Project Name: Lincoln BRF 0188(8)

Structure Identification: TH 1, Bridge 19

The bridge railing fabrication drawings associated with Item 525.34, Bridge Railing, Galvanized 4 Rail Box Beam, have been reviewed and are being returned herewith.

All sheets are approved as noted.

HSC JOB NO. **2041**
SHEET NO. **1 of 4**

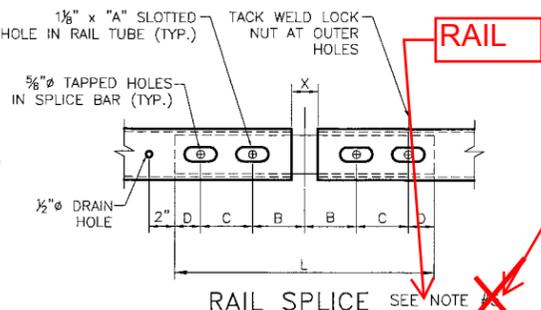
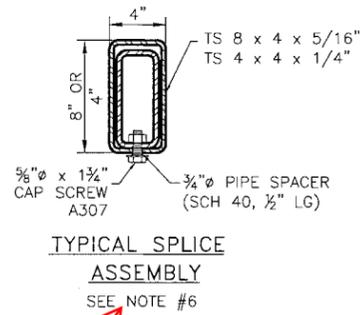
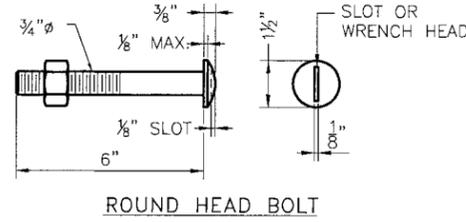
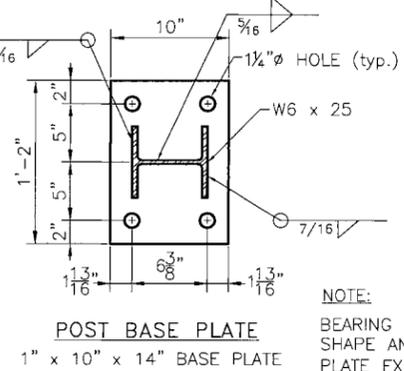
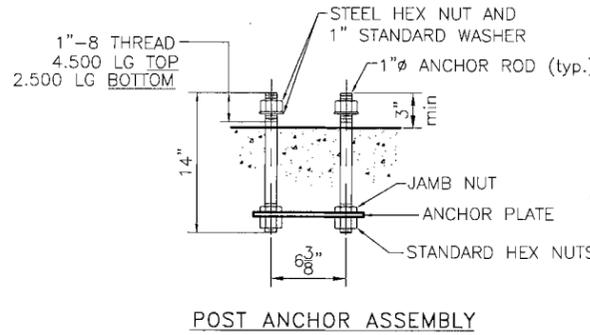
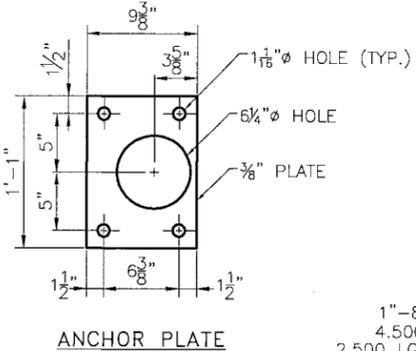
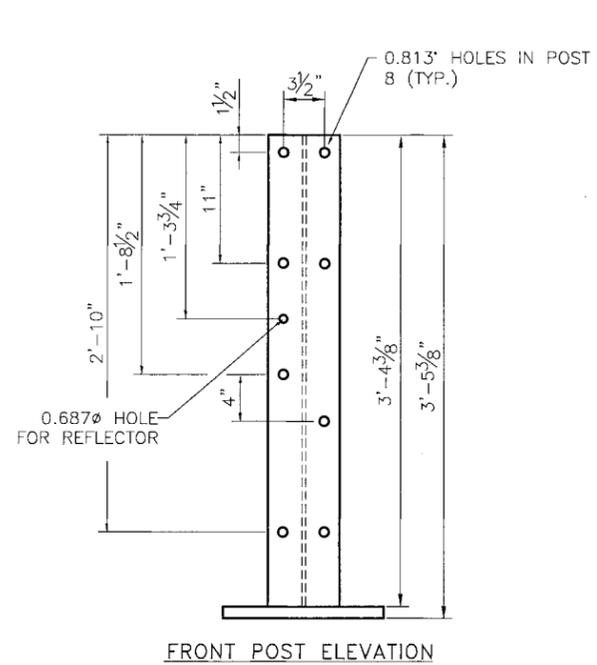
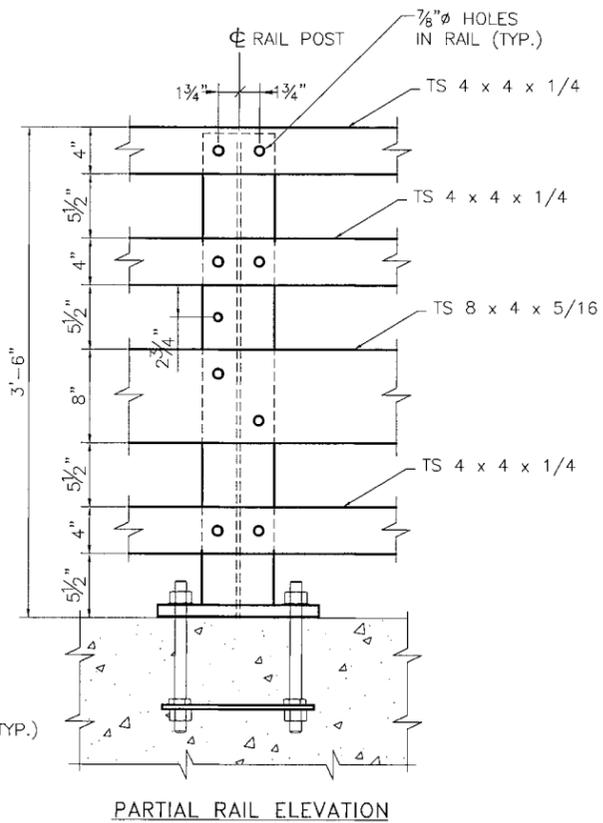
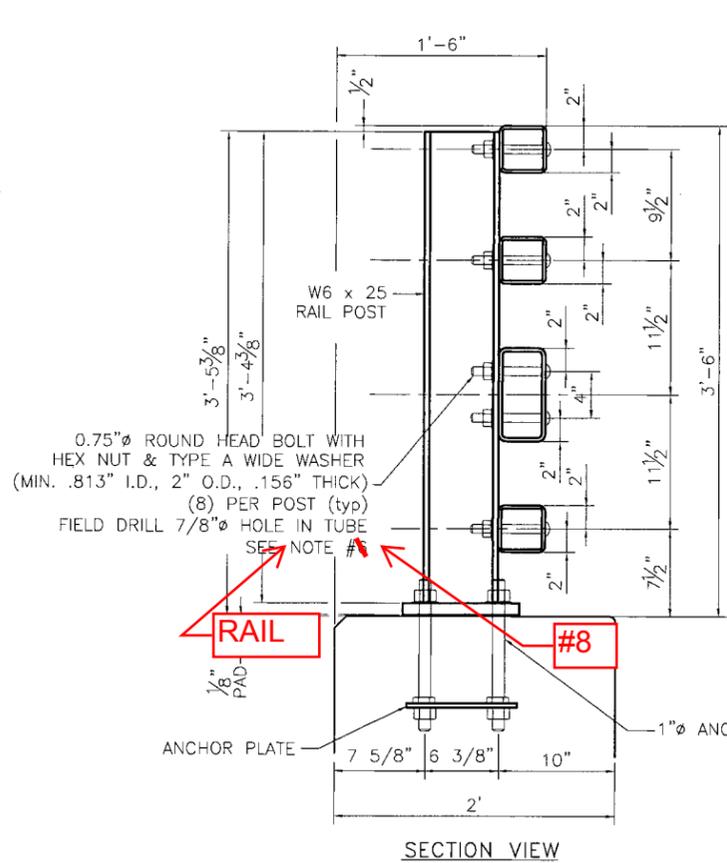
- AT INTERIOR SPLICES, PIPE SPACERS SHALL BE USED ON ONLY ONE SIDE OF THE SPLICE TO ALLOW MOVEMENT ON THAT SIDE. ~~THE TOP AND BOTTOM RAIL~~ SHALL RECEIVE THE SAME TREATMENT, AT END SPLICES PIPE SPACERS SHALL BE USED ON BOTH SIDES OF THE SPLICE TO ALLOW MOVEMENT ON EACH SIDE.

- MILL OR SHOP TRANSVERSE WELDS SHALL NOT BE PERMITTED ON ANY RAIL ELEMENT. RAIL ELEMENTS USED ON ~~CURVES~~ SHALL USE 3/8" WALL TUBES AND SHALL BE SHOP FORMED TO THE REQUIRED CURVATURE.

- RAIL POSTS AND BASE PLATES SHALL CONFORM TO THE REQUIREMENTS OF ASTM A572 GR 50, EXCEPT ANCHOR PLATES ~~AND NUTS~~ A36. SEE SUBSECTION 732.03
 - 3/4" Ø ROUND HEAD BOLTS SHALL BE ASTM A325 OR A449. ALL OTHER BOLTS AND NUTS SHALL CONFORM TO ASTM A307 AND ASTM 563 GRADE A RESPECTIVELY OR BETTER. ANCHOR RODS SHALL CONFORM TO ASTM A449 EXCEPT THAT ASTM A307 NUTS MAY BE USED ON THE BOTTOM OF ANCHOR ASSEMBLY. WASHERS SHALL BE HARDENED STEEL COMMERCIAL TYPE A PLAIN WIDE WASHERS AND SHALL MEET THE DIMENSIONAL REQUIREMENTS OF A.N.S.I. B18.22.

- PREFORMED BEARING PADS (1/8" THICK) SHALL CONFORM TO AASHTO M251.
 - A DELINEATOR (SEE VAOT STANDARD DRAWING G-1 FOR DETAILS) SHALL BE INSTALLED AT NEAREST POST TO 30 FT SPACING. WHITE IS TO BE INSTALLED ON THE DRIVER'S RIGHT. ~~FOR ONE WAY BRIDGES, YELLOW IS TO BE INSTALLED ON THE DRIVER'S LEFT.~~ PAYMENT SHALL BE INCIDENTAL TO OTHER ITEMS.
